APPENDIX B – REQUESTS FOR ADDITIONAL INFORMATION

Section 1 of WCAP-17079-P, "Supplement 3 to BISON Topical Report RPA 90-90-P-A SAFIR Control System Simulator," (hereafter Supplement 3) states:

Figure 2 Example of invalid component connection [A.3]

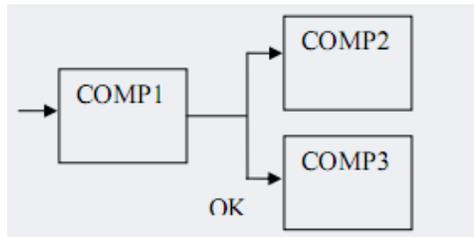
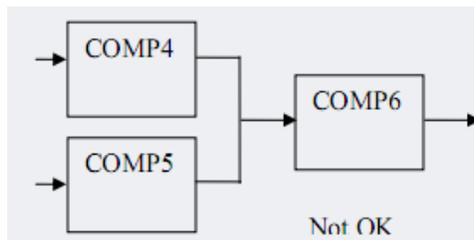
Section 3.11 of Supplement 3 states that a signal can only be connected to one single output. There may be measured plant signals for a plant-specific configuration that is used for multiple control system inputs. Please describe how such a configuration is modeled in SAFIR. As appropriate, please provide a specific example to assist the staff in understanding the approach taken. [A.1]

A SAFIR component calculates an output signal that has to be unique within the SAFIR model, i.e. there may not be two identically named output signals. The signal flow is from an output connection to one or several input connections. An output signal may be connected to several input connections to components as shown in Figure 1 below. A signal may not be calculated by more than one component as shown in Figure 2.

The response to RAI-9 states that the signal flow is from an output connection to one or several input connections. The uniqueness of the output signal is maintained if the output signal is connected in this way. A connection of more than one component to a single input connection would destroy the uniqueness of the input signal [A.3].

The staff finds this description of how configurations, that utilize a single input signal for several control systems in SAFIR, is acceptable. (NRR question)

RAI 23, Figure 1 Block schedule of the SAFIR-BISON interface for the pump model [A.2]

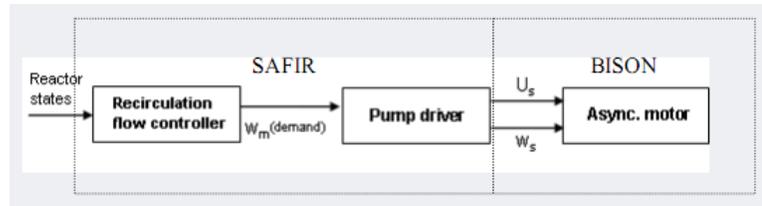
- *We require justification for use of the recirculation pump model when transients are in other than the first quadrants of the Karman-Knapp diagram.*
- *We require justification for use of the recirculation pump model when two-phase flow conditions are calculated.*

Section 3.8, Table 3-1 of WCAP-17079-P indicates that the recirculation pump speeds are output by SAFIR as well as by BISON (i.e., it is listed as both an input to and an output from BISON).

- a) Explain how ABWR reactor internal recirculation pumps are modeled in BISON-SAFIR, including how the pump speeds can be both an input to and an output from BISON, as described in Table 3-1 of WCAP-17079-P.
- b) Provide a qualification analysis, uncertainty analysis, and range of validity demonstrating applicability of the BISON-SAFIR model of the ABWR reactor internal recirculation pumps.
[A.1]

- a) The use of SAFIR for controlling the recirculation pumps does not change the BISON recirculation pump model approved by the NRC and described in RPA 90-90-P-A. The SAFIR code determines the pump speed demand (W_m) by using various plant parameters, which is then transferred to a pump driver that feeds the BISON asynchronous motor model with a frequency (U_s) and a voltage (W_s) as shown in Figure 1 below. The asynchronous motor uses this information to calculate a pump speed which is the input to the BISON recirculation pump model. The BISON code calculates the pump head and pump torque given the pump speed, in accordance with methods as described in RPA 90-90-P-A. Since SAFIR can be used to control the recirculation pumps, the pump speed can be both an input and an output to the model if the pumps are in speed control mode. If the pumps are in speed control mode, the pump controller uses the current pump speed to calculate the error in pump speed (pump demand minus the current pump speed) to determine the means to maintain a constant pump speed.
